# Carbon-Free by 2050

## Pathways to Achieving North Carolina's Power-Sector Carbon Requirements at Least Cost to Ratepayers

**Prepared for North Carolina Sustainable Energy Association, Southern Alliance for Clean Energy, Natural Resources Defense Council, and the Sierra Club**

July 20, 2022

**Figure 11. Capacity Expansion “Typical Day” Load Shape, Example**

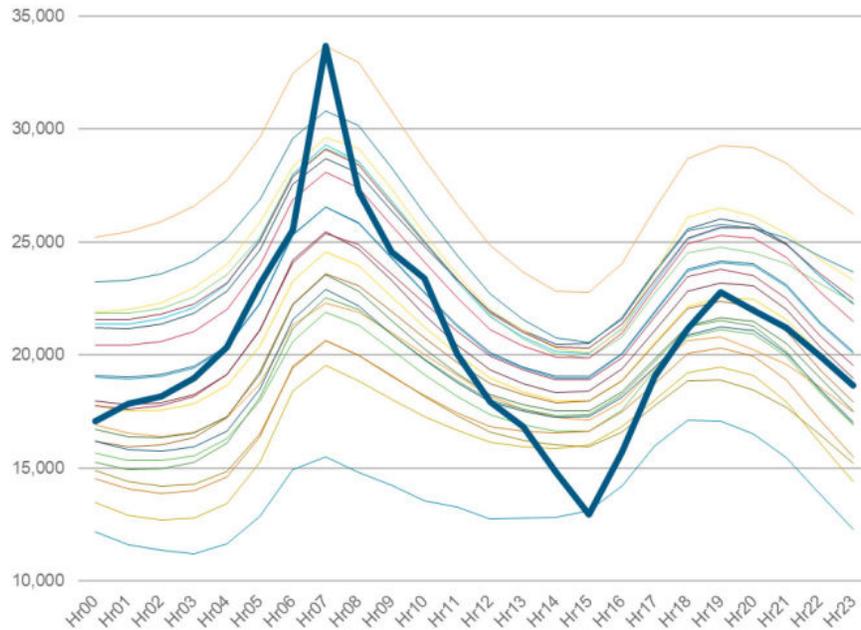
Duke Energy’s justification for the manual replacement of battery storage selected by EnCompass with gas CT capacity is that the “typical day” load construct used by EnCompass to ensure that resource portfolios can serve a wide variety of conditions favors battery storage technologies that can serve a narrow ‘peak’ over CTs that can provide capacity over a longer period. Figure 2 provides an example of this “typical day” load shape.

First, while it is true that the Duke Energy’s capacity expansion runs use the “Typical Day” load construct, Duke also applies additional simplifications to system load for these runs. Duke Energy’s capacity expansion runs condense each 24-hour day into six 4-hour intervals.<sup>35</sup> This interval represents the smallest unit of time available to EnCompass during one of Duke’s modeling runs: load is constant over the course of a single interval, and dispatch choices, for example, cannot change during an interval. Therefore, at a minimum, any “peak” observed in the capacity expansion would need to be at least four hours in duration. Given this additional transformation, “Typical Day” daily peak loads are not, in fact, modeled as “needle peaks.”

Second, Duke Energy’s proposed remedy to this solution contemplates substituting only one resource type—gas-fired CTs—for one other resource type—battery storage. This approach runs directly counter to the resource planning principle of allowing all resources to compete and choosing the most economical portfolio. Solar generation, for example, would generate a substantial portion of its energy between Hour 9 and Hour 15 on Figure 11. Some combination of solar and other resources, including longer-duration storage, might have even more cost-effectively addressed load, but Duke Energy did not consider other configurations of resources beyond additional CTs. Duke Energy did not provide the PVRR value of this replacement in their proposed Carbon Plan, nor did it cite any specific reliability standard in justifying these replacements.<sup>36</sup>

**Figure 12. Manual Changes to Duke Energy Portfolios through 2035 and 2050, Duke Energy Portfolio 1**

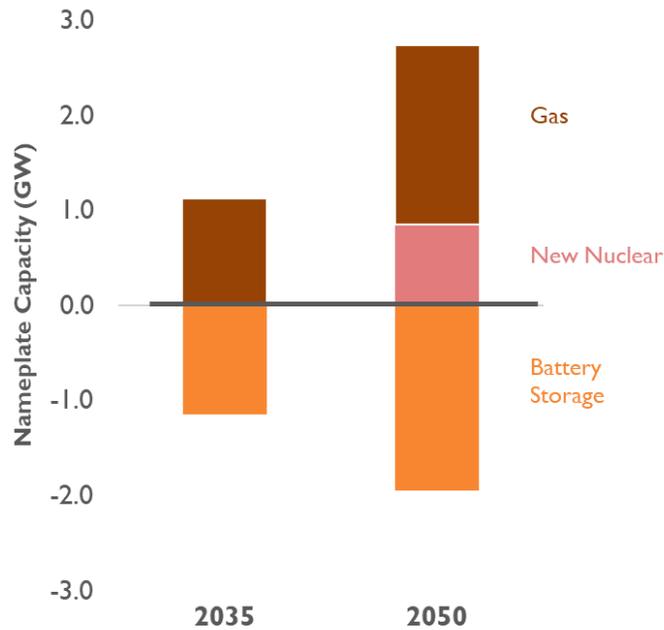
Duke’s manual revisions had a sizable impact on the system capacity mix for Duke Energy’s portfolios. Figure 12 below shows the cumulative impact of manual revisions on Portfolio 1.

For context, the total nameplate capacity of Duke Energy’s generation fleet across all resources today is roughly 40 GW; the 5 GW net change in 2050 represents roughly one eighth of Duke Energy’s total nameplate capacity today. This represents a substantial deviation from the portfolio selected by EnCompass’s economic optimization software. As stated above, these resources were not subject to the declining HB 951 carbon mass cap that guided EnCompass resource selection in Duke Energy’s initial cost runs. Given that Duke Energy adds gas and removes energy storage in the first half of the planning period, this might help to explain why some of Duke Energy’s portfolios fail to meet carbon reduction requirements by their intended dates.<sup>44</sup>
